Attention: Megan Fu  
Project: Nihon University Newcastle Campus - SSD 9787  
Re: Conditions of Consent B03

Re: 17-0347 – Nihon University Newcastle Campus - Architect's Design Statement 01

Revision: 02  
Date: 23/04/2020

Extract from amended drawing A-108:

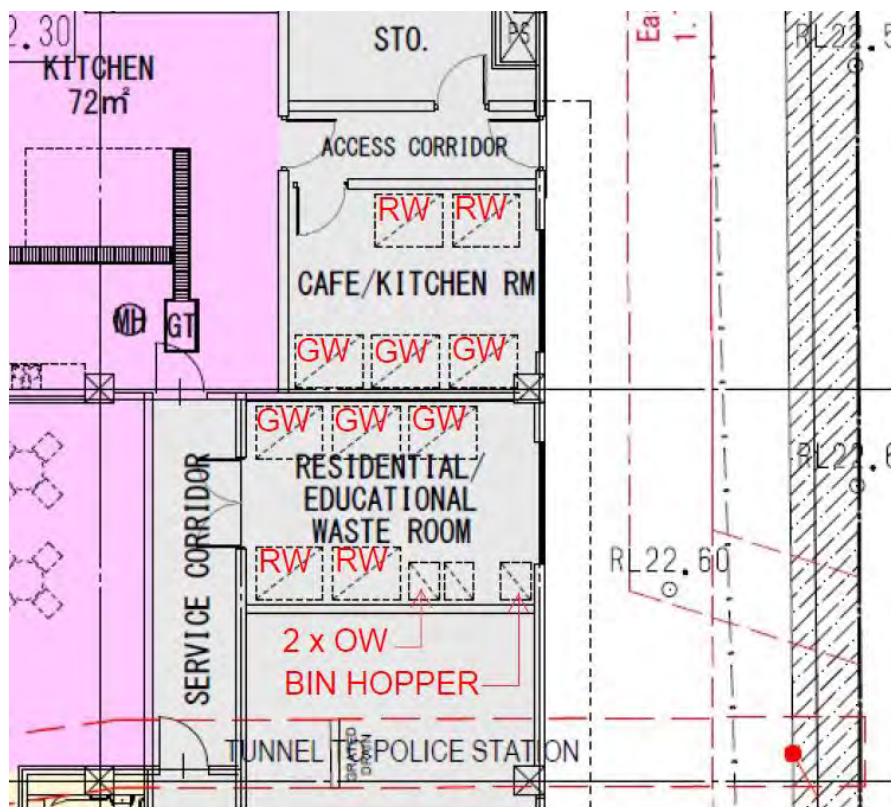
There is no provision in the WMP for green waste management. The Plan needs to outline how green waste generated at the site will be managed.

The design of each of the Waste Storage rooms have been amended as follows:

Please refer to updated drawing A-108, Rev 1 with amendments to the layout and configuration of the waste rooms as indicated above.
